**Economic and Social Council**Distr.: General  
7 August 2023

**World Forum for Harmonization of Vehicle Regulations****Working Party on Lighting and Light-Signalling****Eighty-ninth session**

**Simplification of lighting and light-signalling UN Regulations****Proposal for a Supplement to the 00 and 01 series of amendments to UN Regulation No. 150****Submitted by the Informal Working Group on Simplification of Lighting and Light-Signalling Regulations\***

“Figure A5-VII

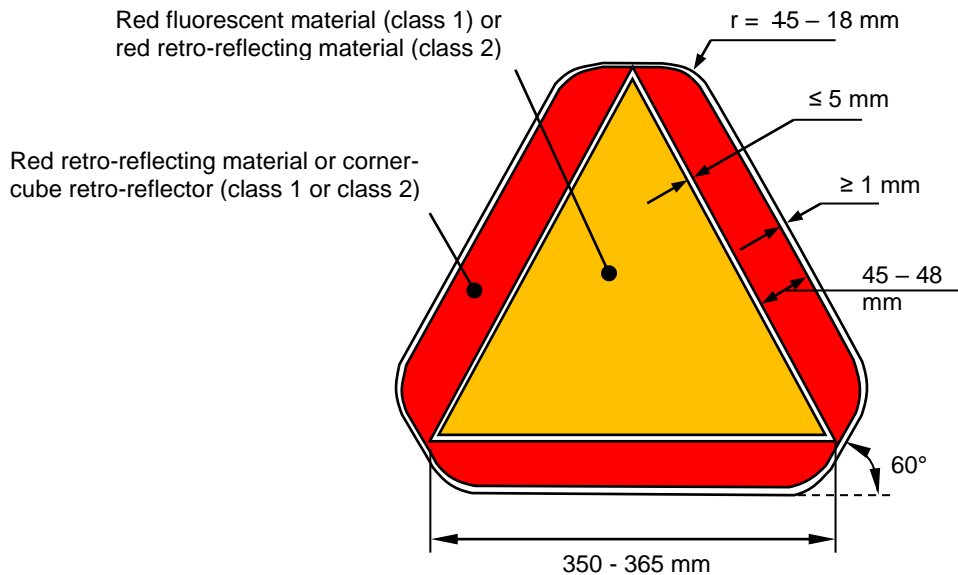
Figure A5-VI “Example of a slow-moving vehicle plate”, amend to read:

*Figure A5-VI “Example of a slow-moving vehicle plate”*

2. By mistake there are two “Figures A5-VI” in the text of the 00 series of amendments to UN Regulation No. 150. The one entitled “*Example of a slow-moving vehicle plate*” has been renumbered as Figure A5-VII.
3. During the simplification process, the value “ $r = 5 - 18 \text{ mm}$ ” (as in the 02 series of amendments to UN Regulation No. 69, Annex 12), inadvertently became “ $r = 15 - 18 \text{ mm}$ ”. The proposal corrects this error.

The length of the base of the enclosed fluorescent triangle (class 1) or retro-reflective triangle (class 2) shall be: minimum 350 mm and maximum 365 mm. The minimum width of the light-emitting surface of the red retro-reflective border shall be 45 mm, the maximum width 48 mm. These features are illustrated in the example of Figure A5-VI ~~A5-VI~~ A5-VII.”

“Figure A5-VII  
**Example of a slow-moving vehicle plate**

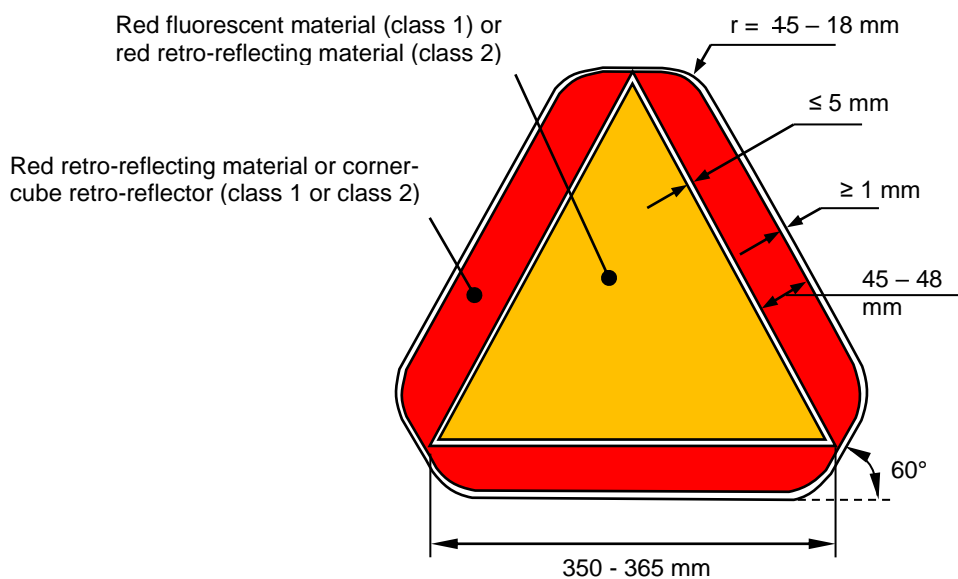
Figure A5-VII, amend to read:

*Figure A5-VII*

7. During the simplification process, the value “ $r = 5 - 18 \text{ mm}$ ” (as in the 02 series of amendments to UN Regulation No. 69, Annex 12), inadvertently became “ $r = 15 - 18 \text{ mm}$ ”. The proposal corrects this error.

“7.3. Dimensions  
The length of the base of the enclosed fluorescent triangle (class 1) or retro-reflective triangle (class 2) shall be: minimum 350 mm and maximum 365 mm. The minimum width of the light-emitting surface of the red retro-reflective border shall be 45 mm, the maximum width 48 mm. These features are illustrated in the example given in Figure A5-VI A5-VII.”
